Project Address 3615 Chandler Parkway Zip Code 98226Tax Assessor Parcel Number (s) 380316 372176 0000Project Description Residential Multi-Family Planned Development of townhouses and single-family residences on an undeveloped 492,344 sqft (11.303 Acre) lot. Development will include an extension of Sussex Drive.Applicant / Agent ☐ Primary Contact for ApplicantName Tony Freeland, Freeland & Associates, Inc.Mailing Address 220 West Champion Street; Suite 200City Bellingham State WA Zip Code 98226Phone 360-650-1408 Email tfreeland@freelandengineering.comOwner (s) ☐ Applicant ☐ Primary Contact for ApplicantName Dominion Sustainable DevelopmentMailing Address P.O. Box 31548City Bellingham State WA Zip Code 98228Phone 360-319-0898 Email david@ebenal.com

Subject: Plat of Barkley Heights
Response to Request for Improved Information

We have reviewed the requests for improved information dated December 4, 2020 regarding the Plat of Barkley Heights permit submittal. Below is a summary of significant changes.

PRELIMINARY STORMWATER PLAN

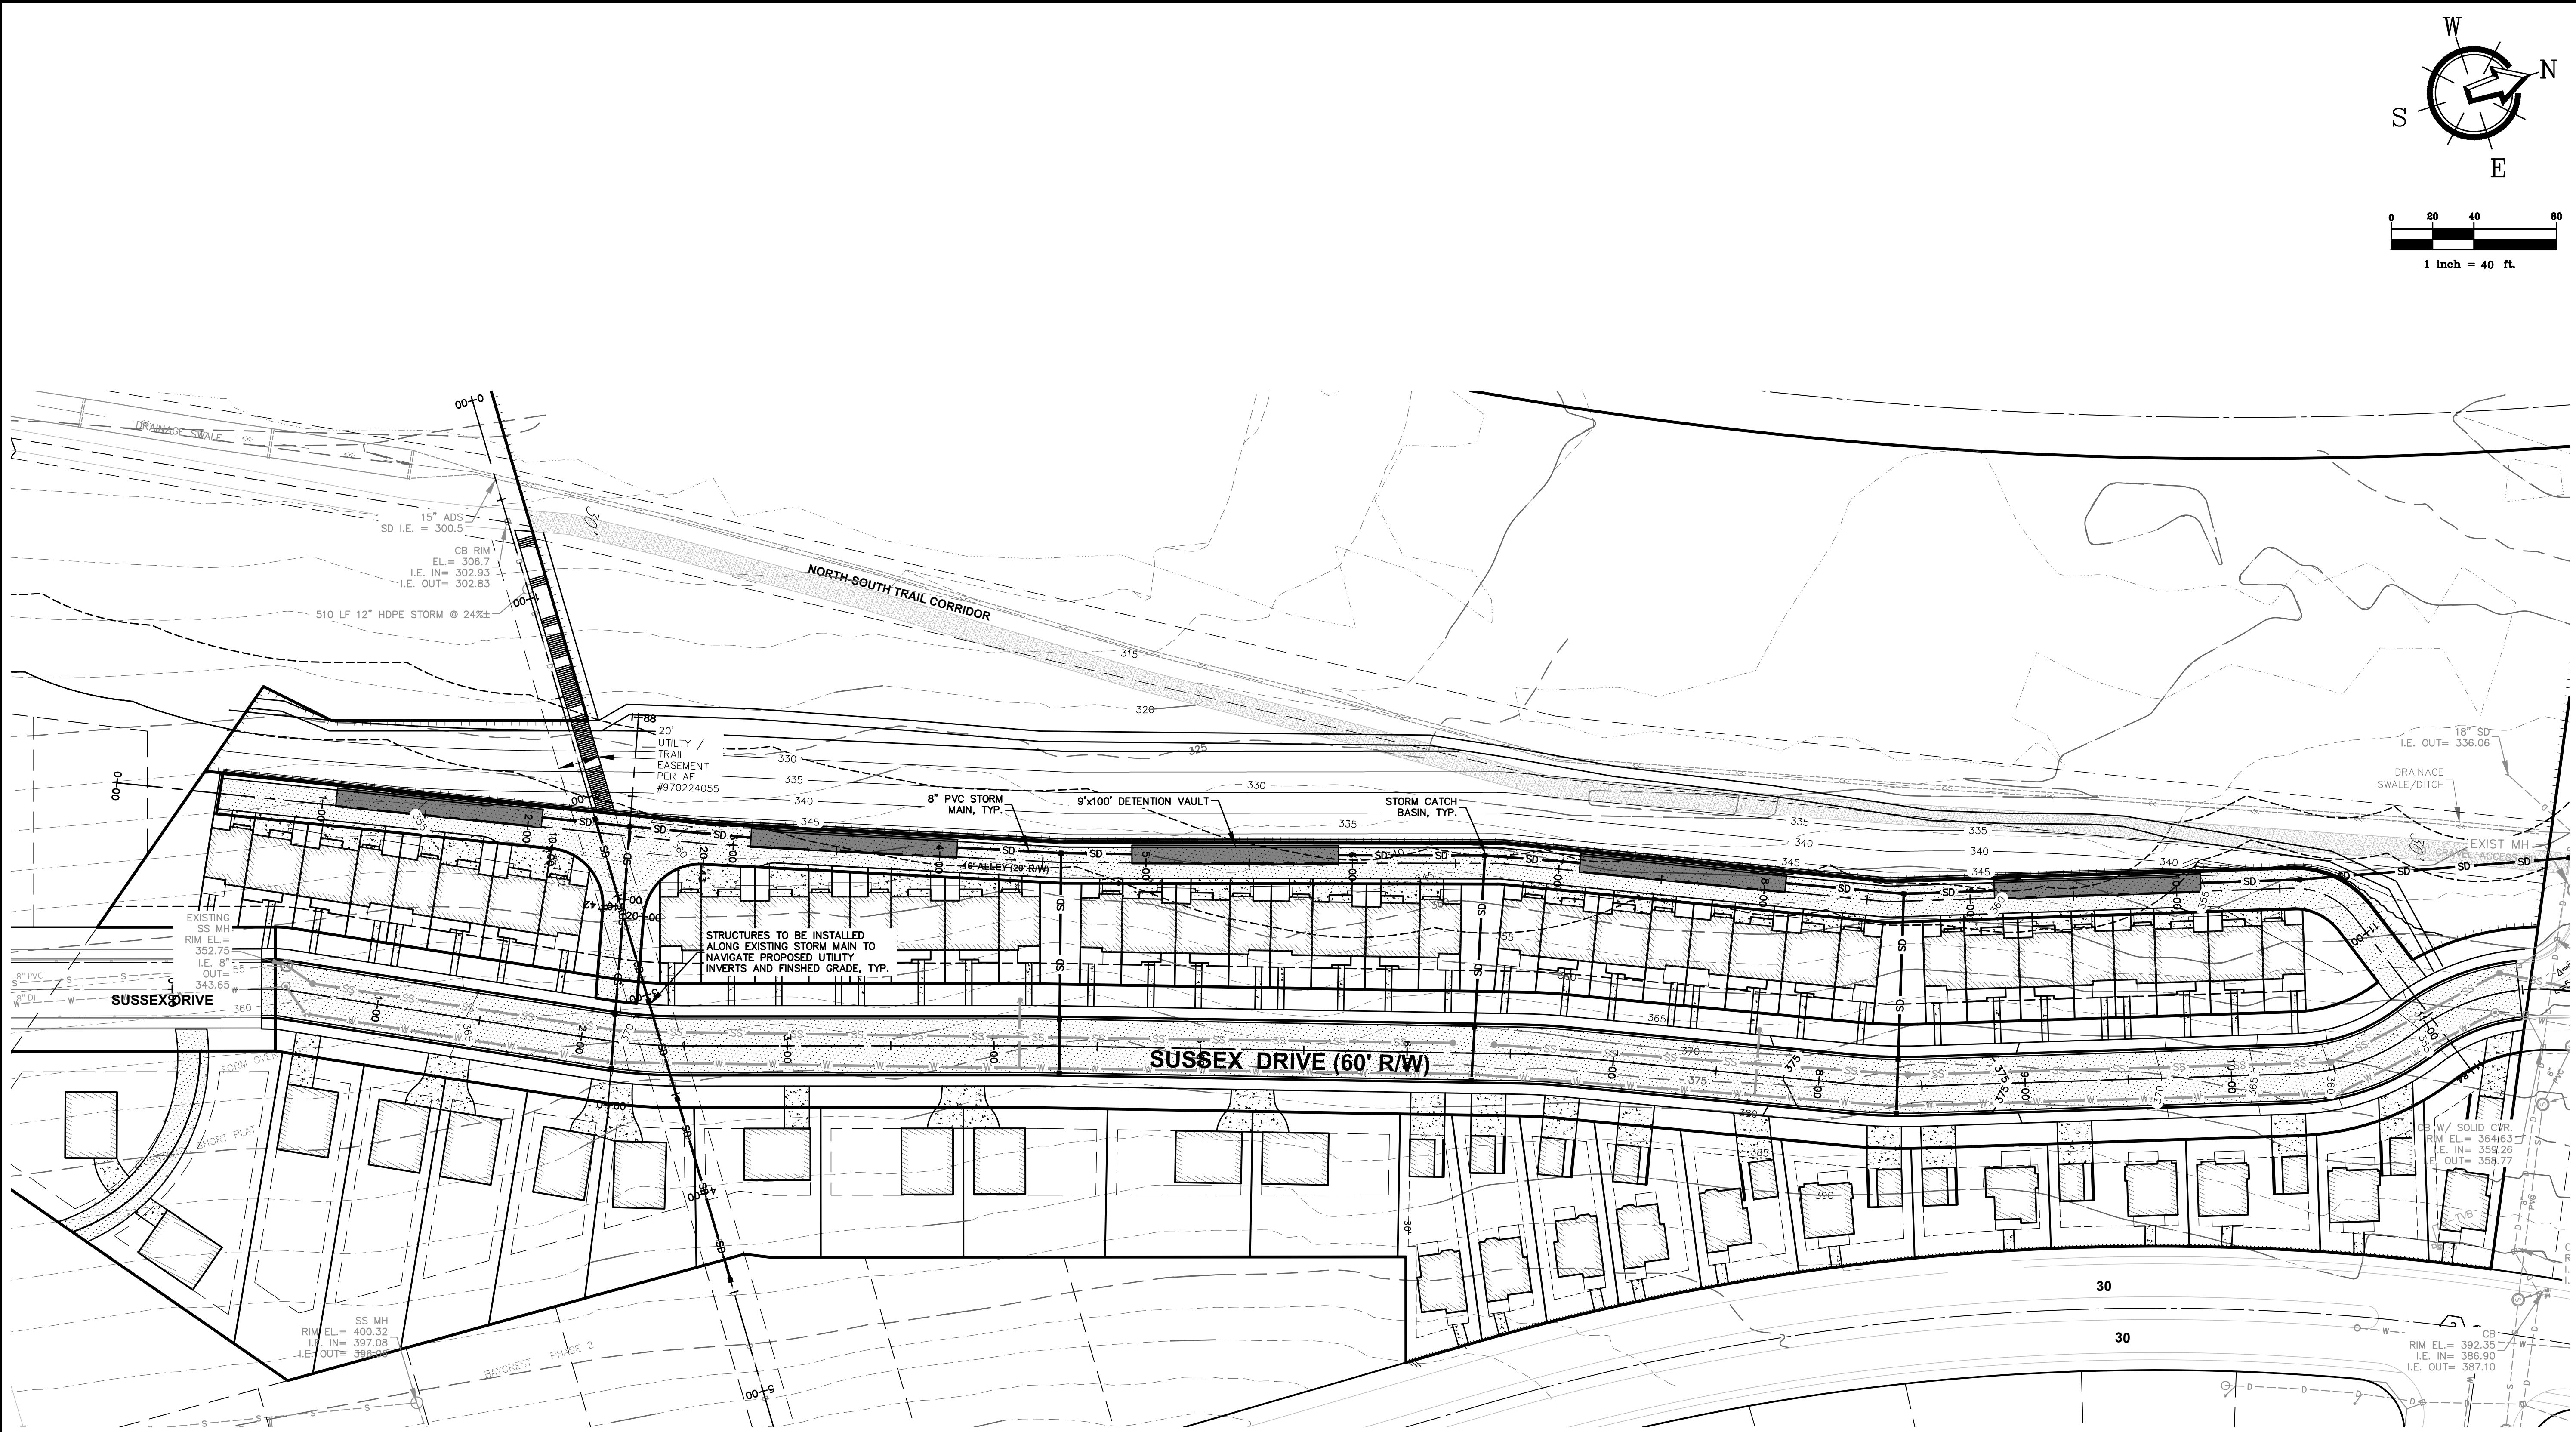
- There is not sufficient information to demonstrate the overall stormwater plan will meet code;

- The stormwater plan doesn't address soils or wetland hydrology.

Response: The cast-in-place detention tanks shown have been conservatively sized based on preliminary modeling. The storm design will be very complicated so note realistic to do a complete design for preliminary plat.

Response: Wetland hydrology will be maintained per code. Currently the drainage ditch cuts off most flow to the wetlands as noted in the mitigation report. The storm outfall is proposed into the same ditch. Final design will involve more detailed modeling of this.
